Subject: Transmittal of Revision 1 to Service Bulletin Number
V2500-ENG-72-0240..

International Aero Engines SERVICE BULLETIN

ENGINE - HIGH PRESSURE TURBINE ROTOR AND STATOR ASSEMBLY - PROVIDE A NEW STAGE 2
HPT AIR SEAL AND NEW STAGE 1 HIGH PRESSURE TURBINE (HPT) HUB METERING PLUGS

V2500-ENG-72-0240

Before and After Views of Configuration Changes That Affect The Stage 2 High
Pressure Turbine (HPT) Air Seal Assembly
Figure 1

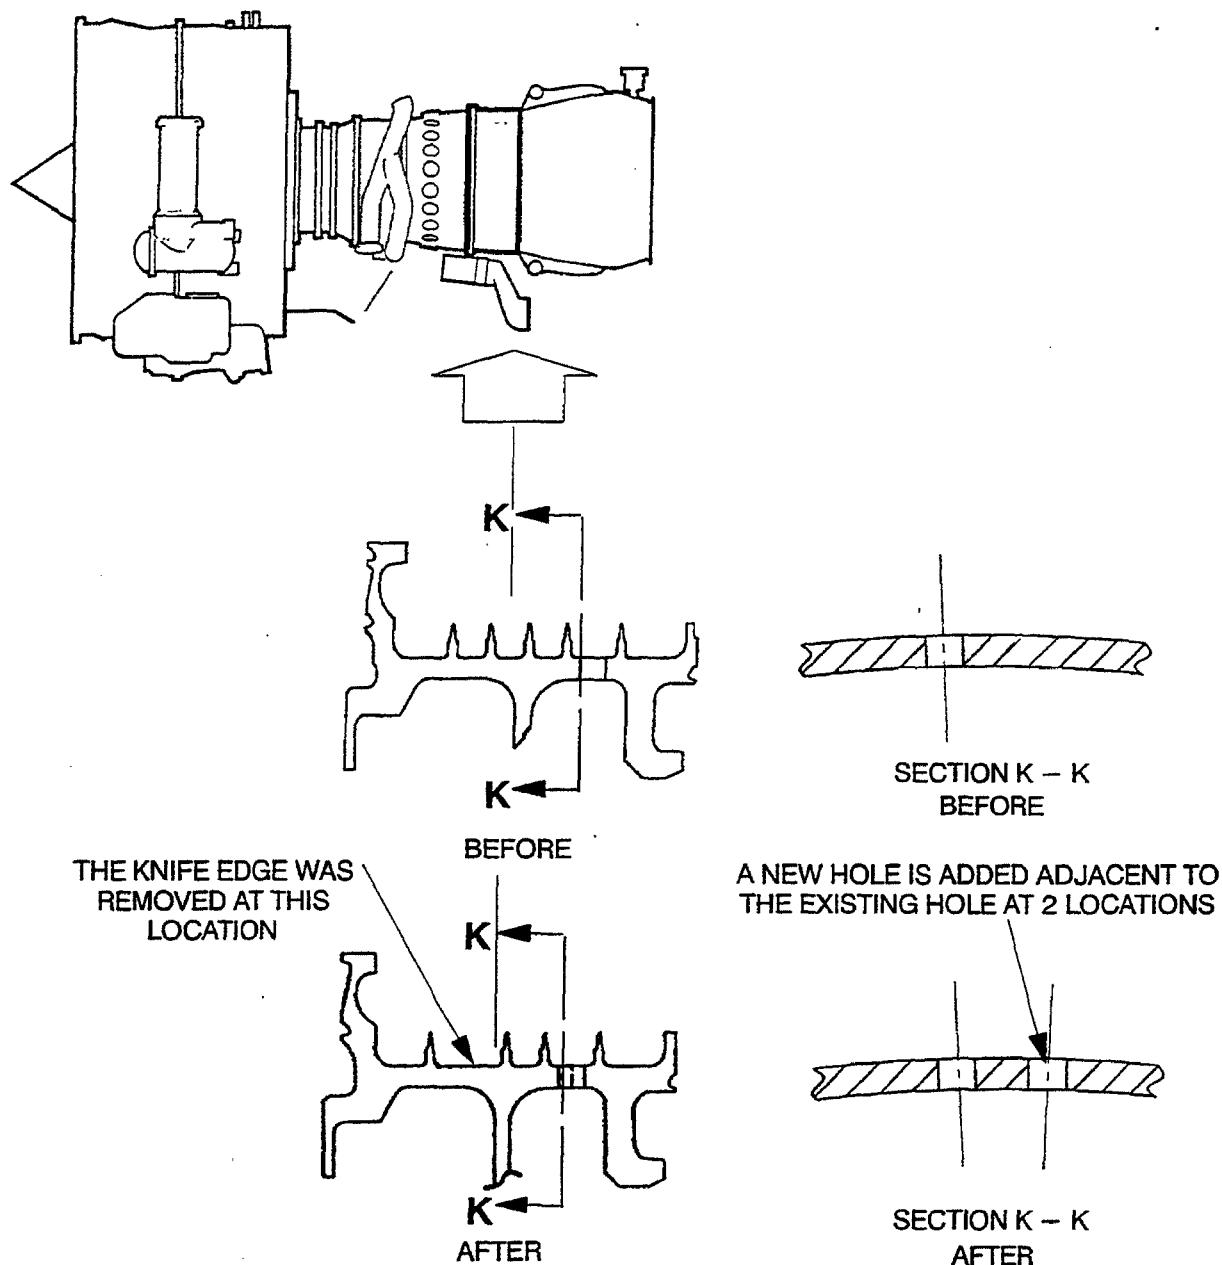
Provide a new Stage 2 High Pressure Turbine (HPT) Air Seal that has additional cooling holes and one less knife edge to reduce heat pick up. New Stage 1 HPT Metering Plugs are also required. This will aid in reducing the operating temperatures in the area of the Stage 2 Air Seal outer cavities. The new Stage 2 Air Seal in combination with the new Stage 1 Hub Metering Plugs, will become the new standard for V2500-A5/D5 Engine Models. A new air seal assembly will also be provided for V2500-A1 Engines to retain part commonality.

- (b) Set-up and machine to Refer to Figures 1 through 3.
remove the knife edge
seal.

Location of the Stage 2 High Pressure Turbine (HPT) Air Seal (Assembly)
Figure 2

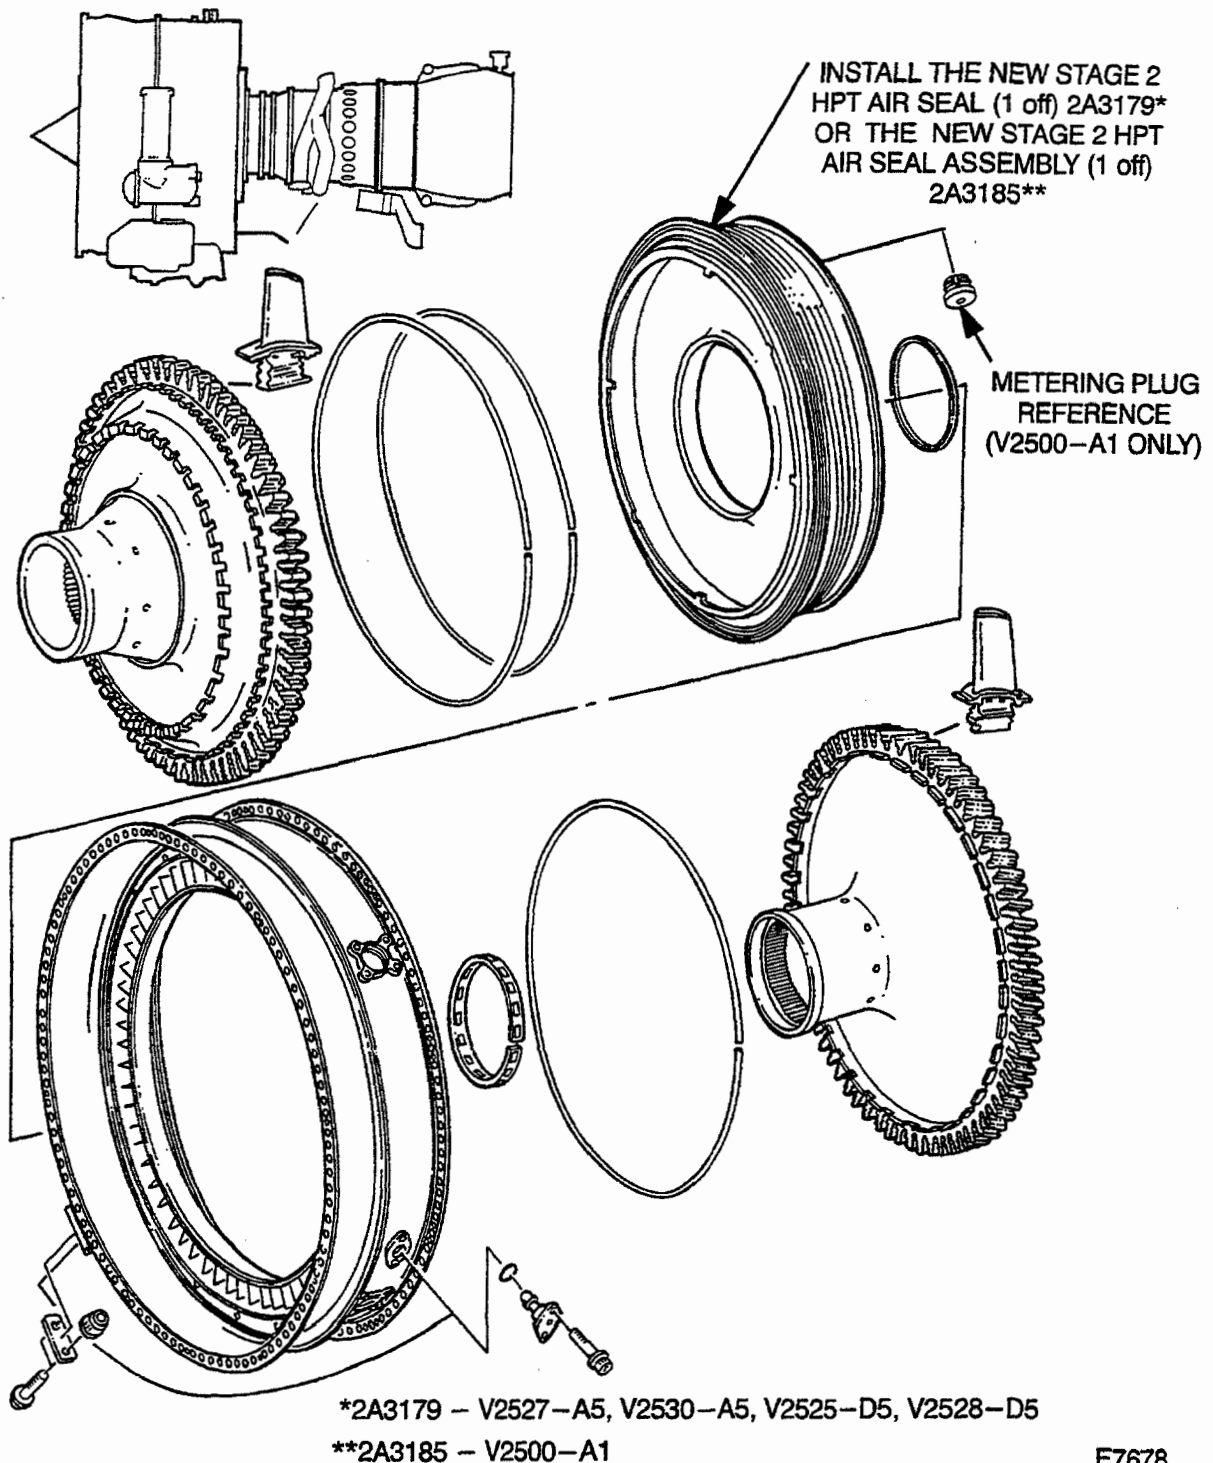
- (a) Remove two plugs that you Refer to Figure 2.
will not install again
after modification.

Location of the Stage 1 High Pressure Turbine (HPT) Metering Plugs
Figure 3

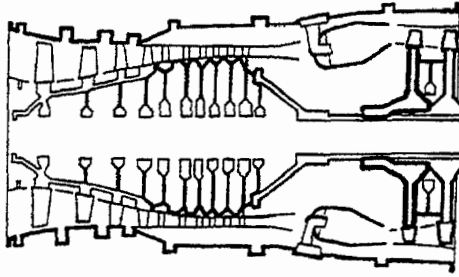
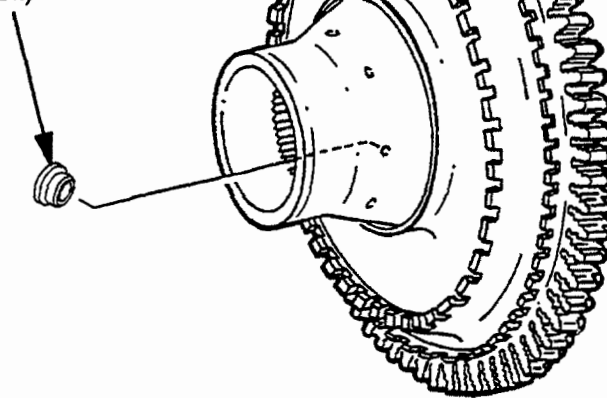
- (2) Replace the 2A2354 Stage 1 High Pressure Turbine (HPT) Hub Metering Plugs (24 off) with 2A3182 by the procedure given in Reference (1), Chapter/Section 72-45-11, Repair-02 VRS3187 (for V2527-A5 and V2530-A5 Engines) or Reference (2), Chapter/Section 72-45-11, Repair-02 VRS3187 (for V2525-D5 and V2528-D5 Engines). See Figure 3.

REPLACE THE 2A2354 STAGE 1
HIGH PRESSURE TURBINE (HPT)
METERING PLUGS WITH 2A3182
(24 off)

Modification of the Stage 2 High Pressure Turbine (HPT) Air Seal Assembly
Figure 4

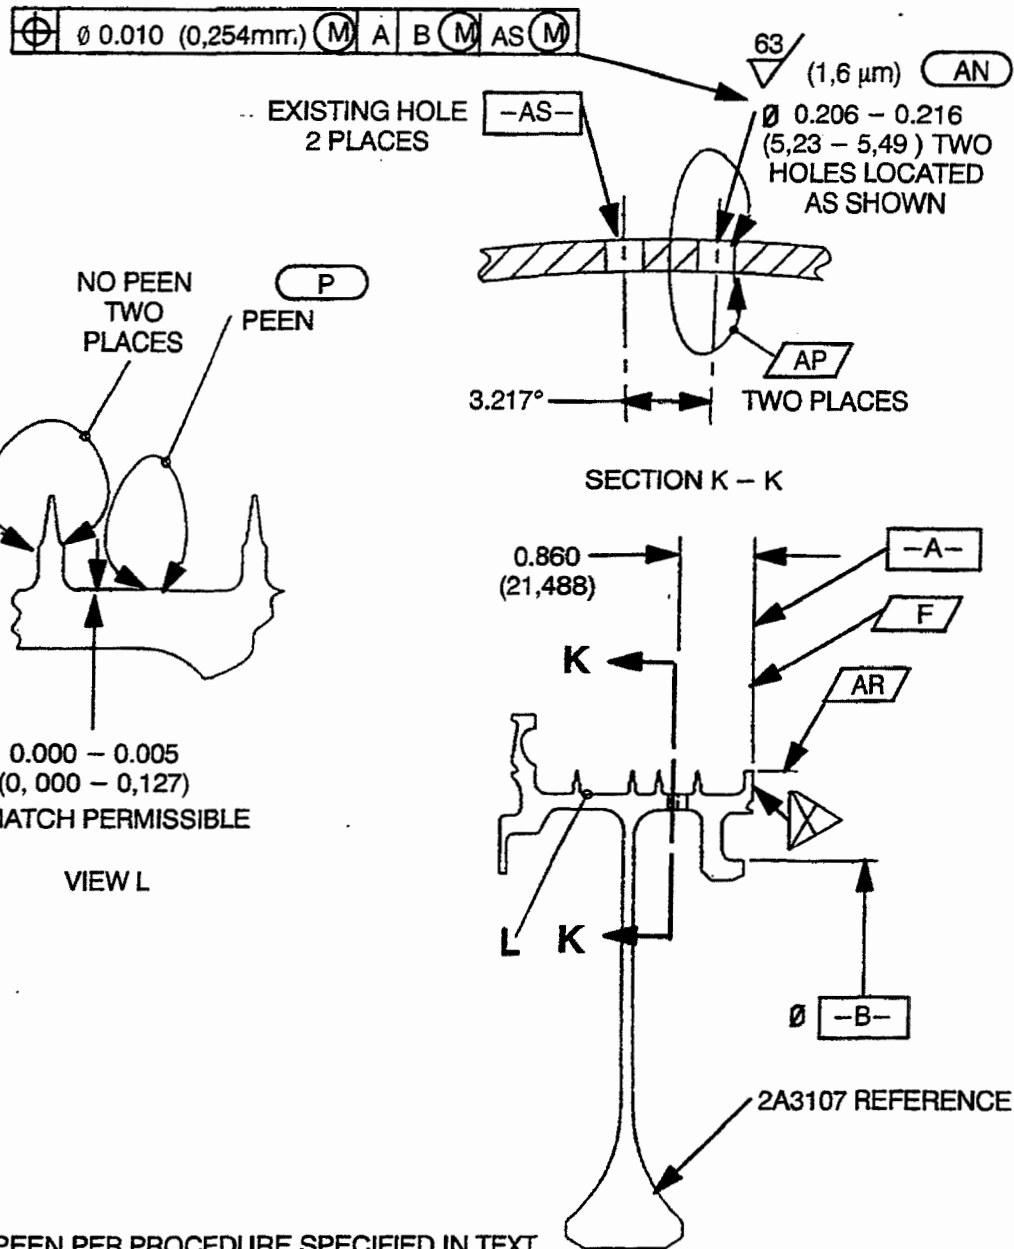
- R (c) Set-up and machine two 0.206 - 0.216 in. (5,23 - 5,49 mm) diameter holes. Refer to Figure 4.
- R (d) Finish the holes by the procedure specified in TASK 70-35-19-350-501. Refer to the approved procedure in Reference (2), Chapter/Section 70-35-19 Hole Blending. Manual butterfly polish is allowed.

- (e) Do a fluorescent penetrant inspection by the procedure specified in TASK 70-23-04-230-501 or by the procedure specified in TASK 70-23-05-230-501. No cracks are permitted. Refer to Figure 4. Refer to the approved procedure in Reference (2), Chapter/Section 70-23-04 or Chapter/Section 70-23-05 Fluorescent Penetrant Inspection.

- (f) Shotpeen in the areas specified to an intensity of 4A using SAE 170 maximum cast steel shot (Hardness 45 HRC or equivalent) by TASK 70-38-13-380-501 (AMS 2430). Refer to Figure 4. Refer to the approved procedure in Reference (2), Chapter/Section 70-38-13 Surface Treating.

- NOTE:** Minimum intensity is waived in area AP, but complete coverage is necessary.
- (g) Mark the new part number adjacent to the existing part number. Use the vibration peen method.
